HANFORD 100-BC REACTOR AREA CLEANUP

Will DOE Soil Cleanup Protect Groundwater?
Will DOE Restore Groundwater to Its Highest Beneficial Use?

John R. Brodeur, P.E., L.E.G.
Energy Sciences & Engineering
Kennewick, Wash.

September 2005

(Figure 2)

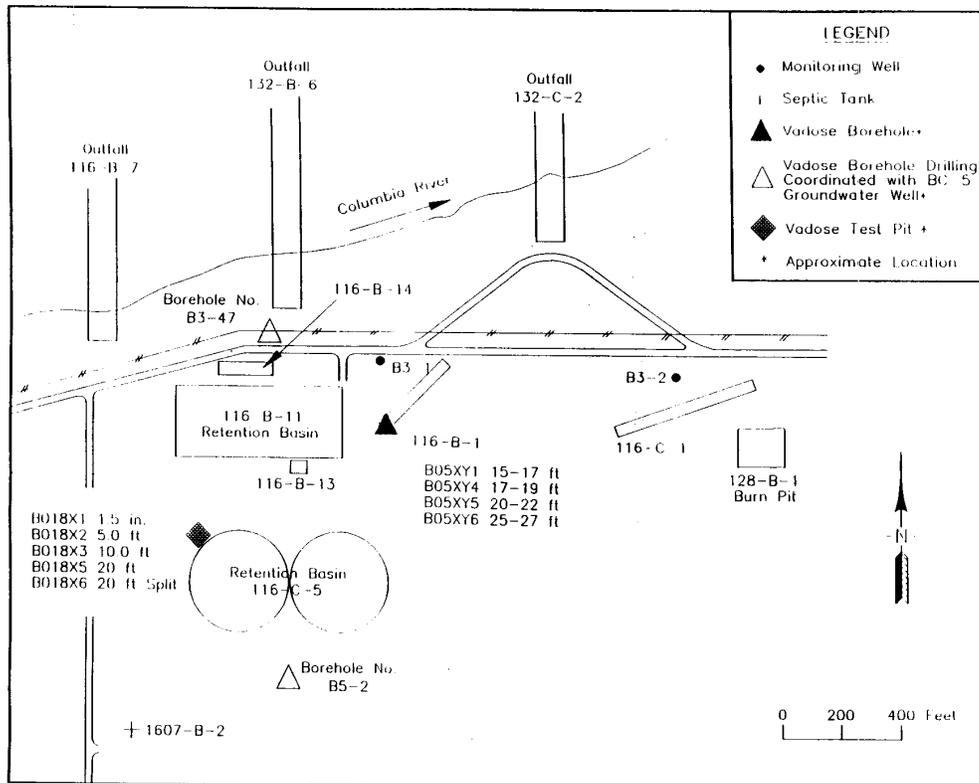
One borehole was drilled through the 100-BC-1 trench as a part of the LFI for the 100-BC-1 OU (Figure 2).. Four samples were taken from depths of 16, 18, 21 and 26 feet. Radionuclide and metals assay data is summarized in Tables 2 and 3. Data shows that from the trench bottom, radionuclide concentrations decrease with depth, to the maximum sampling depth of 26 feet. Unlike D&R, Sr-90 is not an exception to this general trend for the depth range of the data.

(Figure 3)

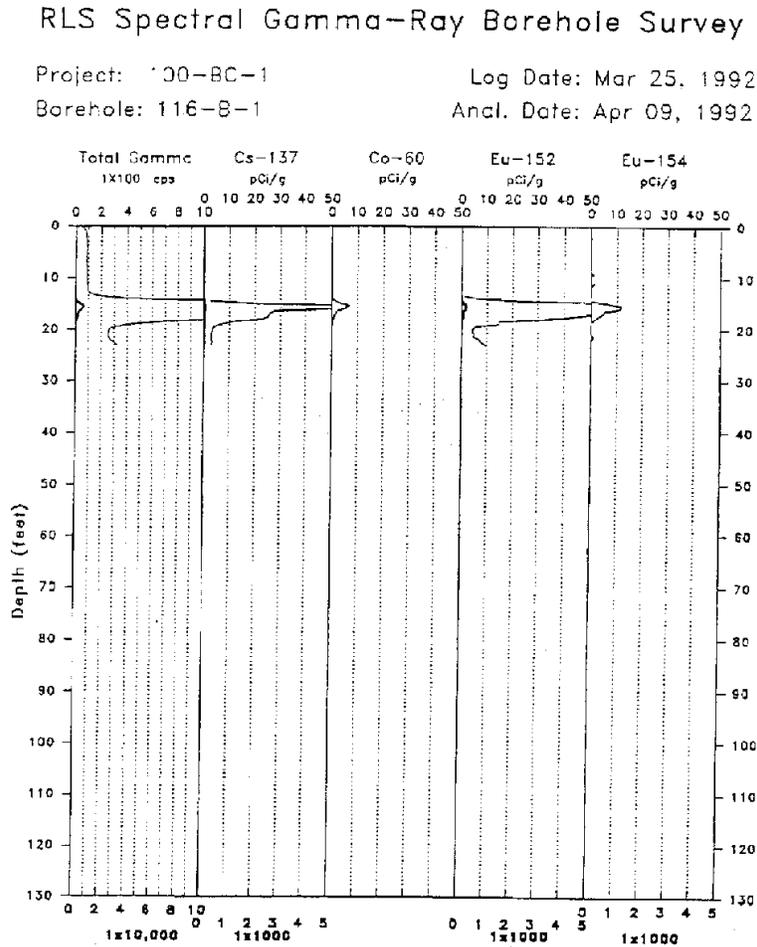
Spectral gamma-ray logging of the LFI borehole (Figure 3) shows the highest Cs, Co and Eu concentrations near the 15 feet depth, which is the bottom of the trench structure. Spectral gamma logs also show the depth extent of cesium and europium has not been reached at 23 feet, the maximum depth of gamma log data.

(Figure 4)

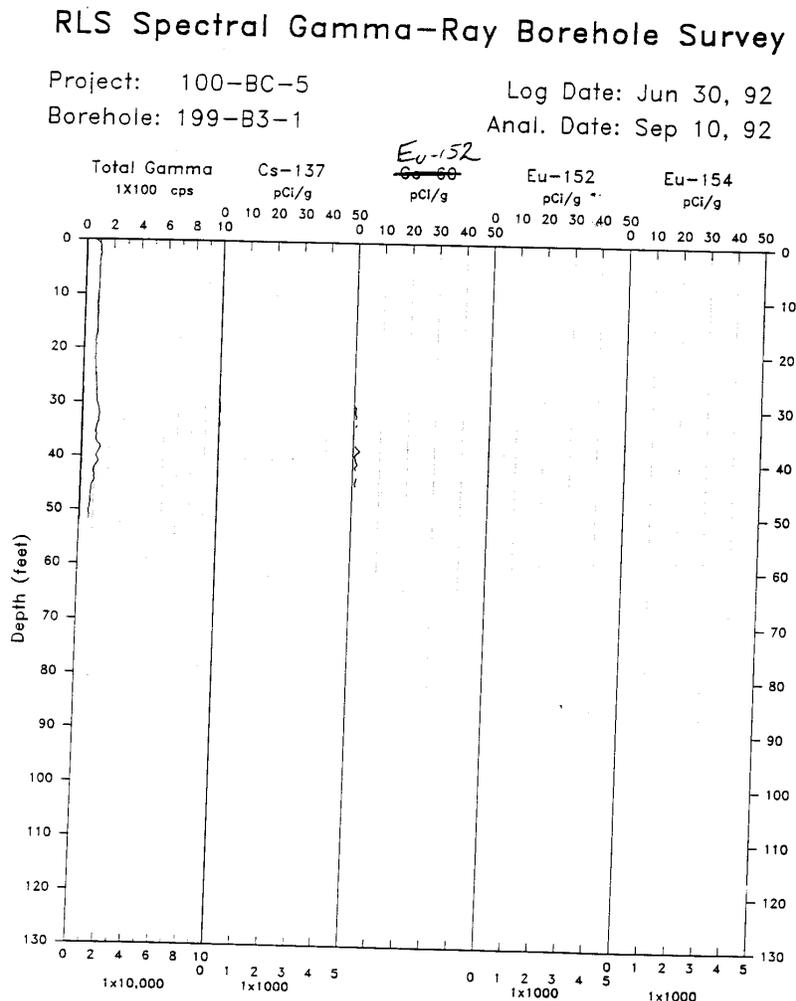
An exceptionally poor plot of some of the spectral gamma ray log data from this groundwater well (Figure 4) shows a region between approximately 30 and 50 feet at which low concentrations of Cs-137 and Eu-152 are found. The concentration representation on the plot is not visible, but it is there. The cesium in particular, is a low-mobility radionuclide and poses a relatively low risk to human health and safety. This low-concentration cesium is interpreted to be the result of unsaturated moisture flow and the migration of contamination from the 116-B-1 trench to the location of this well, approximately 150 feet away. Alternately, it is the same from the C-11 retention basin. Qualified plots of the potassium, uranium and thorium concentrations in this borehole

might be useful for correlating lithology with contamination distribution, but they are not provided.

Figure 9. 116-C-1 Test Pit Data - ¹³⁷Cs, ¹⁵²Eu, ⁶³Ni

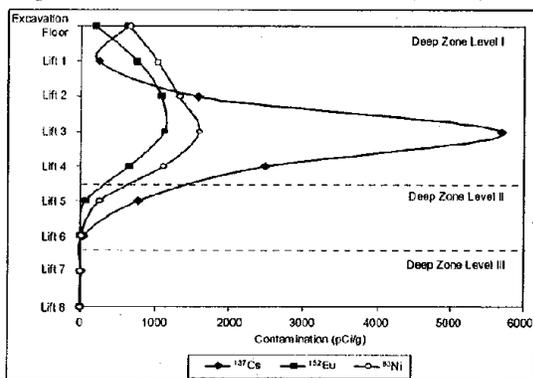
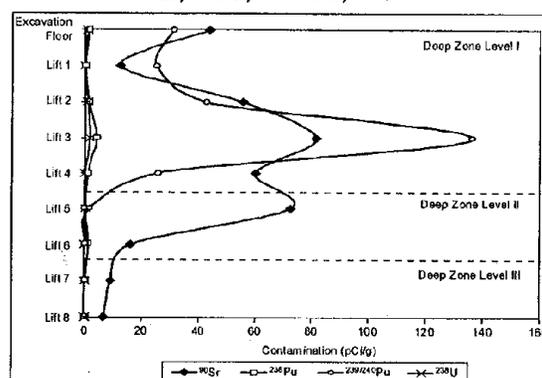
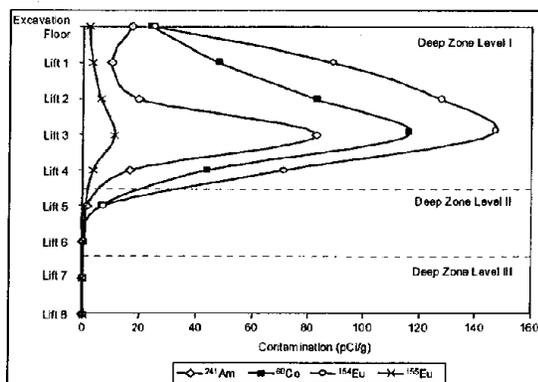
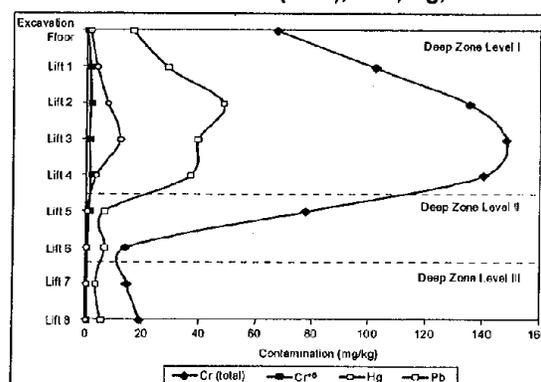
The test-pit data generally confirms the results of D&R (Table 6a); the bulk of the contamination is at or below a depth of approximately 20 feet, which is below the depth of remediation excavation. It is clear from the test-pit data that the limited sampling in D&R missed the bulk of the contamination, as D&R appropriately concluded. The test-pit data provides the only data on the

deeper vadose-zone contamination, with the exception of a single data point from the sample taken from a groundwater monitoring well 150 feet away.

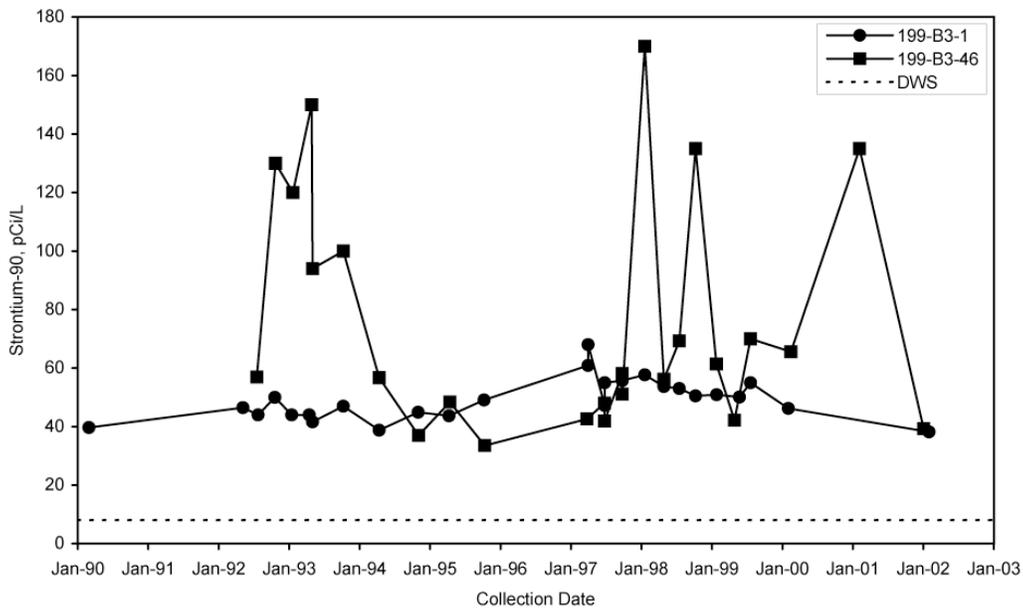
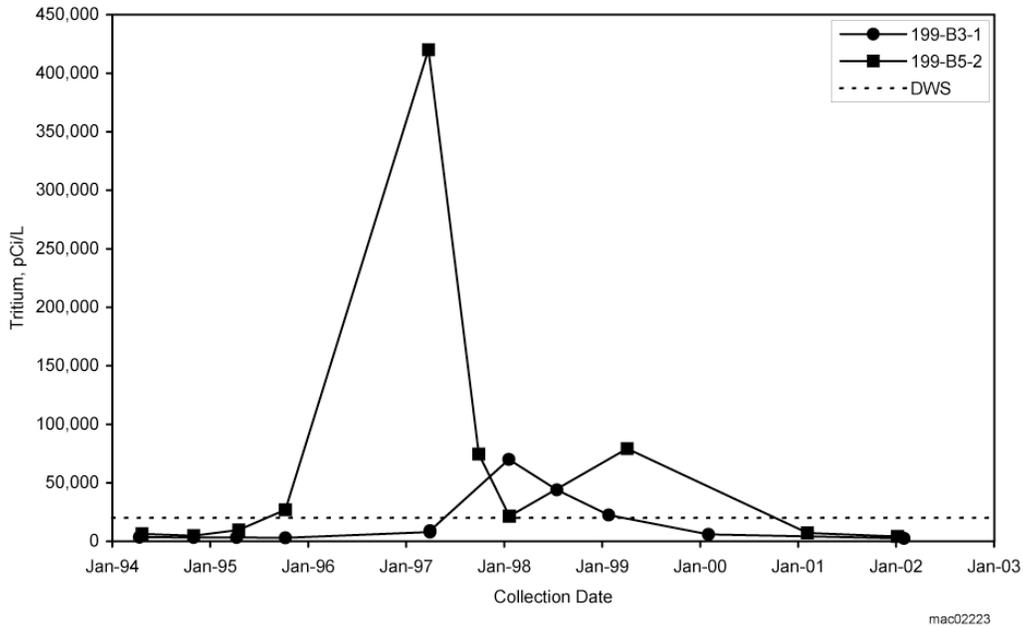
which is approximately ¼ of the RAG. This peak concentration value is calculated to occur in 41 years. Review of the calculation data (Bechtel 1999b appendices) shows that the entire contribution of contamination to groundwater comes from the deepest layer in the deep zone or below approximately 25 feet. This is essentially true for all of the contaminants that are shown to reach groundwater. This means that as far as Sr-90 contamination of the groundwater is concerned, it does not matter what levels of residual contamination is left in anything but the deepest zone. Or, put another way, the deeper zone contamination level is a sensitive parameter in the model.

Because the Sr-90 groundwater concentration is predicted to be ¼ of the RAG, we are not satisfied with this cleanup verification process. No information is provided about the sensitivity of the various parameters that went into the calculation that verified cleanup. Specifically, we do not know how sensitive the residual concentration of the deep layer is to meeting the RAG. If the residual Sr-90 concentration is 10 pCi/g instead of eight, does that cause a failure of the RAG? Considering that only one sample from one deep location went into the verification model, are we justified in relying on that one sample to show what will happen over the entire site?

contamination is determined and considered in a more accurate calculation of groundwater contamination levels? Does the remediation still meet the RAG? Looking at the results of the RESRAD modeling exercise, we doubt that it will. And, if one looks at the groundwater monitoring data for 199-B3-46 (Figure 5b), it is clear what the data suggests.
